LOST CREEK ISR, LLC

**Re: Responses to June 22, 2009 Comments Regarding the Lost Creek ISR Application
TFN 4 6/268**

**RESPONSES to
WDEQ/LQD 2nd ROUND REVIEW
of
APPENDICES D5 and D6**

**for the
LOST CREEK PROJECT
Wyoming**

FIGURE D5-1
Regional Geologic Map
Lost Creek Permit Area

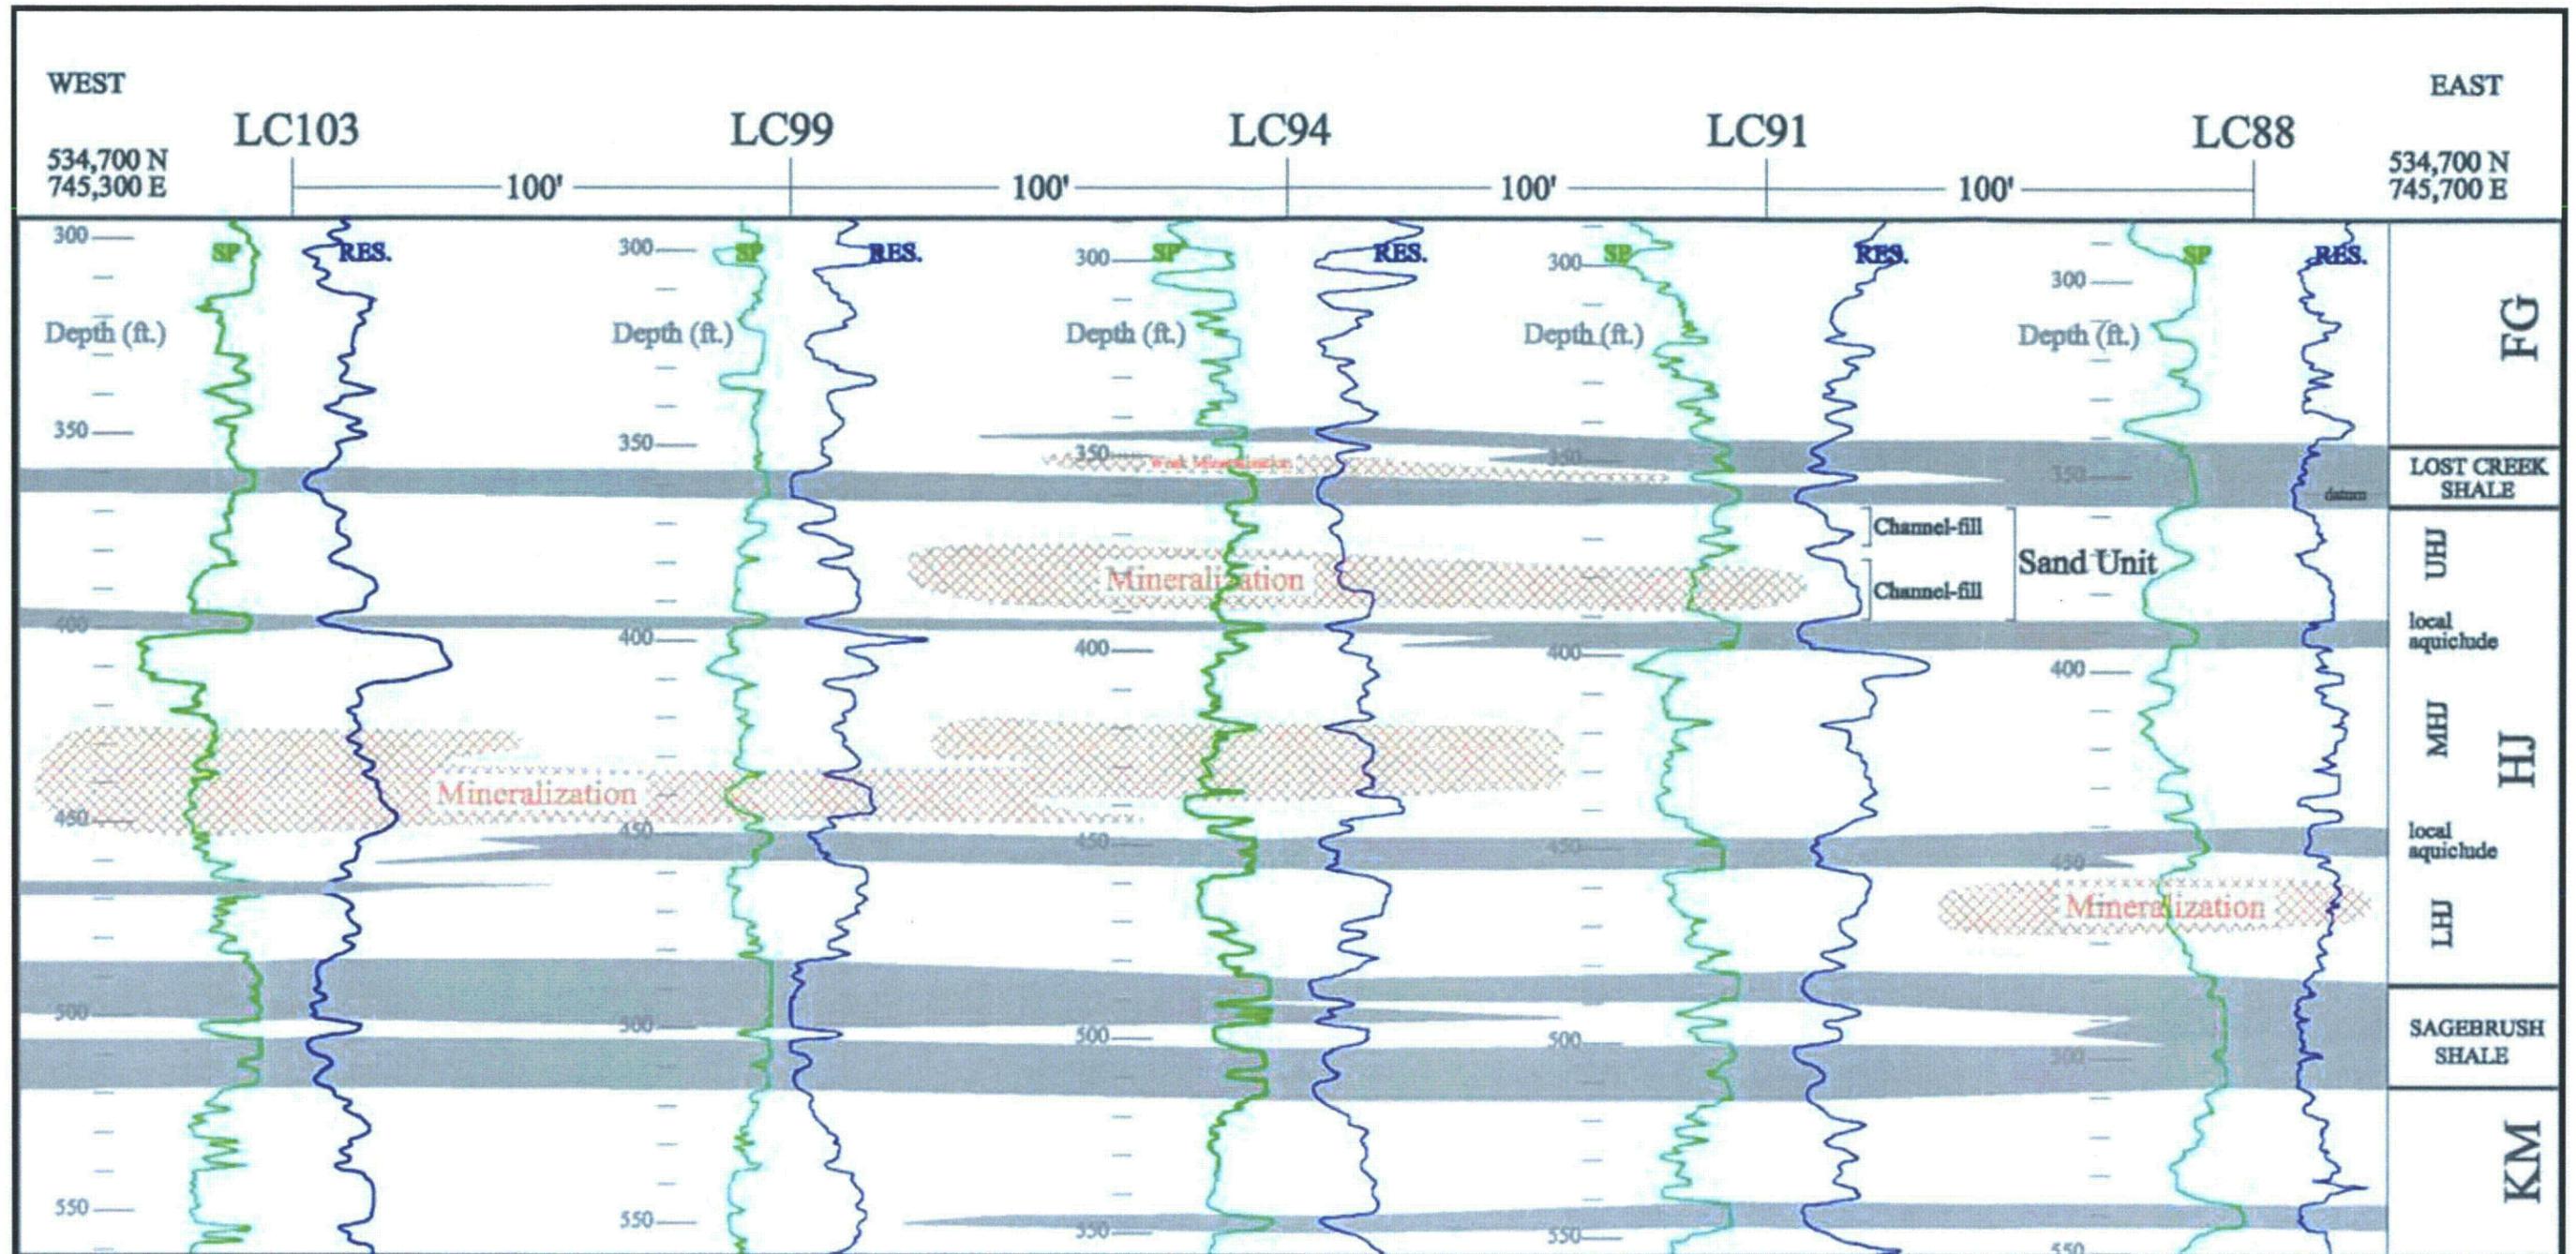
2. LQD (8/08) - *Figure D5-1 is a Regional Geologic Map. This map indicates the faults in the area, but does not indicate the Lost Creek Fault within the permit area. This is a significant and well documented feature within the permit area, and should be indicated on the Figure.*

LQD (6/09) - Figure D5-1 is only intended to depict major regional faults. Since the Lost Creek Fault zone is a minor fault system, it is not illustrated on the regional map. It is, however, illustrated on the property-scale maps. **The legend on Figure D5-1 should be changed to read "Major regional faults".**

LC ISR, LLC (4/09) - Only major regional faults, such as those illustrated on the State of Wyoming geologic map or regional maps, are illustrated on Figure D5-1, "Regional Geologic Map". Some of the faults illustrated on the regional map have displacements of 5,000 feet or more. In contrast, the Lost Creek fault zone is a minor fault system with throws from zero feet to a maximum of 80 feet; therefore, it is not illustrated on the regional map. It is, however, illustrated on the property-scale maps (e.g., Figure D6-13), and more detail about any faulting within the Permit Area that could impact the in situ operations will be provide with the mine unit packages.

LC ISR, LLC (11/09) - The legend on Figure D5-1 has been changed as requested.
